HWY #12 INTERCHANGE  
UNDERPASS

DEPARTMENT OF HIGHWAYS ONTARIO BRIDGE DIVISION	
<b>WYLLIE &amp; UFNAL LIMITED</b> CONSULTING ENGINEERS TORONTO	
<b>HWY. N° 12 INTERCHANGE UNDERPASS</b>	
KING'S HIGHWAY No. CAH. 400 CO. SIMCOE TWP. MEDONTE	DIST. No. 5 LOT 19 CON. XI & XII
<b>GENERAL PLAN</b>	
APPROVED _____ DESIGN DCB DRAWING WYABJRC DATE DEC. 1969	SITE No. 30-362 W.P. No. 906-66-02 CONTRACT No. _____ CHECK KNS CHECK DCB LOADING HS20-44
D-6729-1

FOUNDATION INVESTIGATION REPORT  
For  
Hwy. #12 Interchange Underpass  
Hwy. #400 at Coldwater  
District No. 5 (Owen Sound)  
W.J. 69-F-79 -- W.P. 906-66-02

SUBJECT: Hwy. No. 12 Interchange Underpass  
W.P. 906-66-02, Site 30-362  
Highway 400, District No. 5

**FOUNDATION LAYOUT & PIER DETAILS**

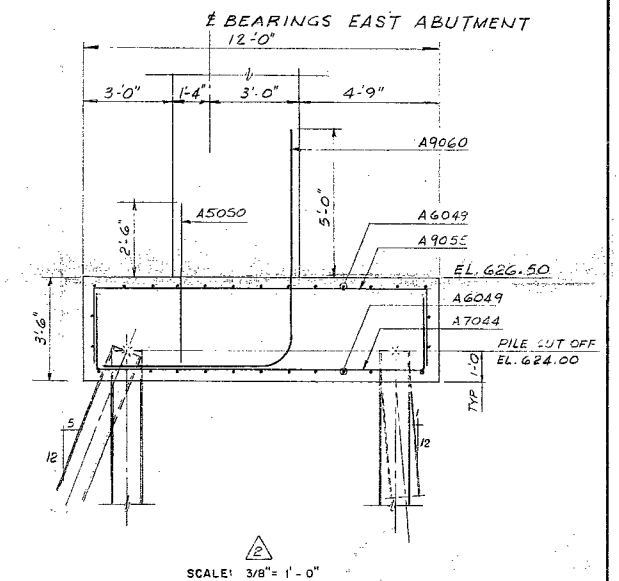
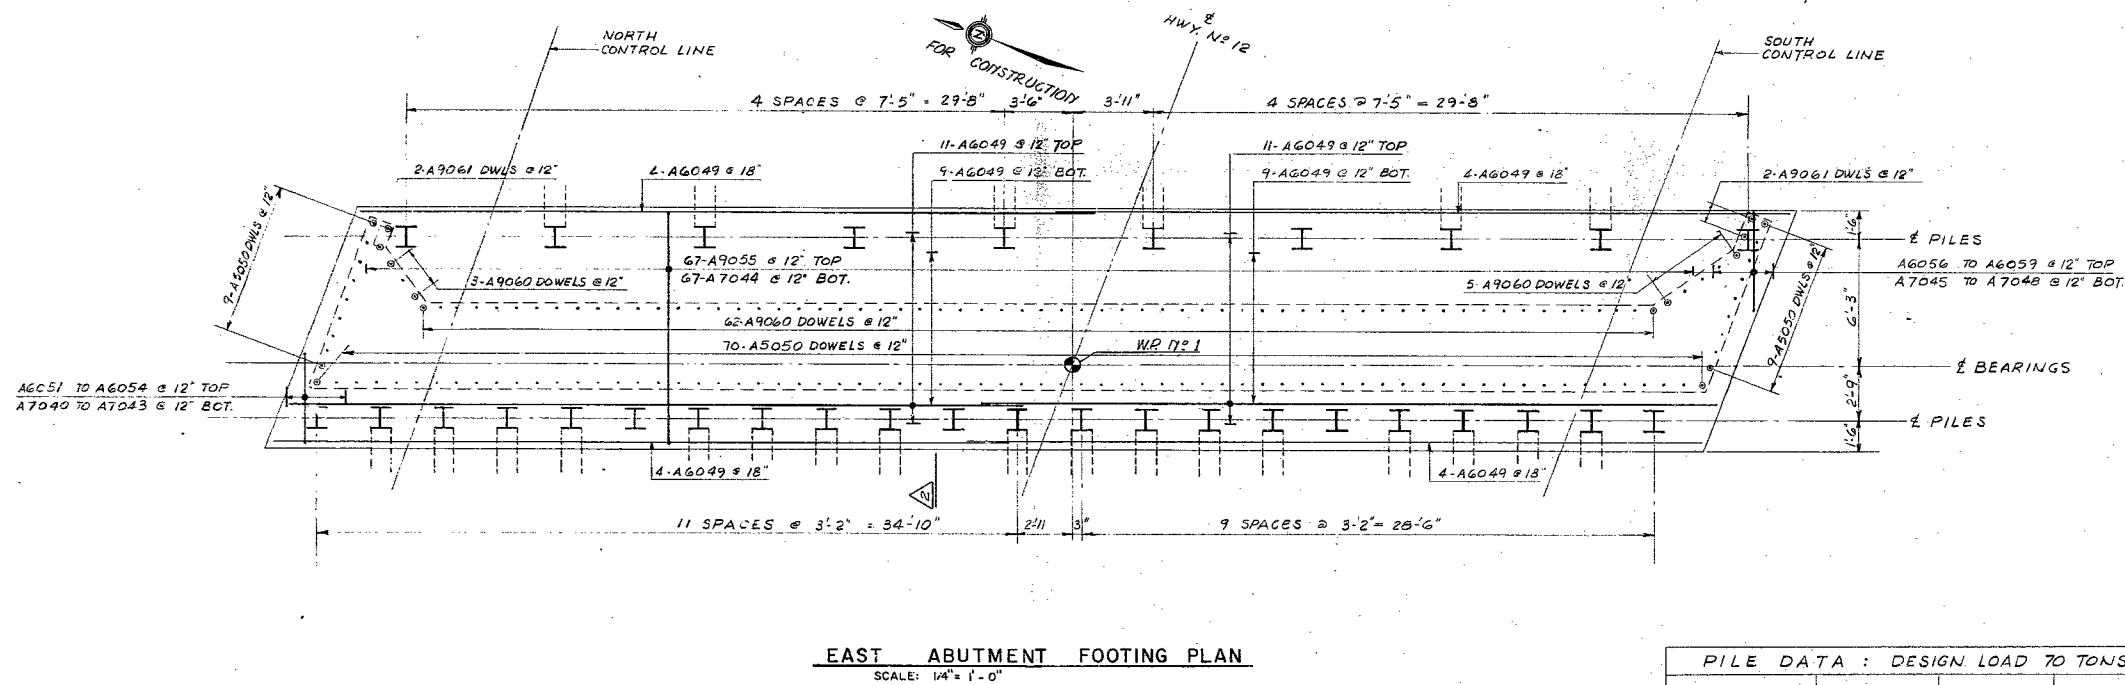
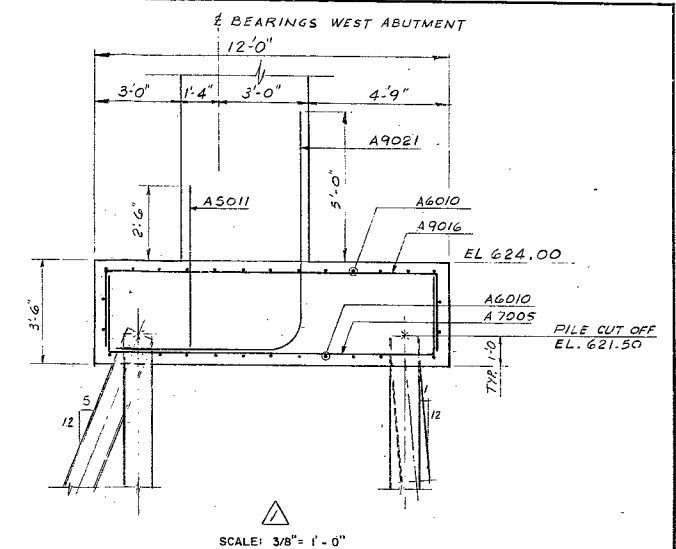
Steel H-piles used for foundation  
for tie pier  
Pile lengths O.K. Pile cap will be founded  
below G.W.L. and will require a  
dewatering scheme.
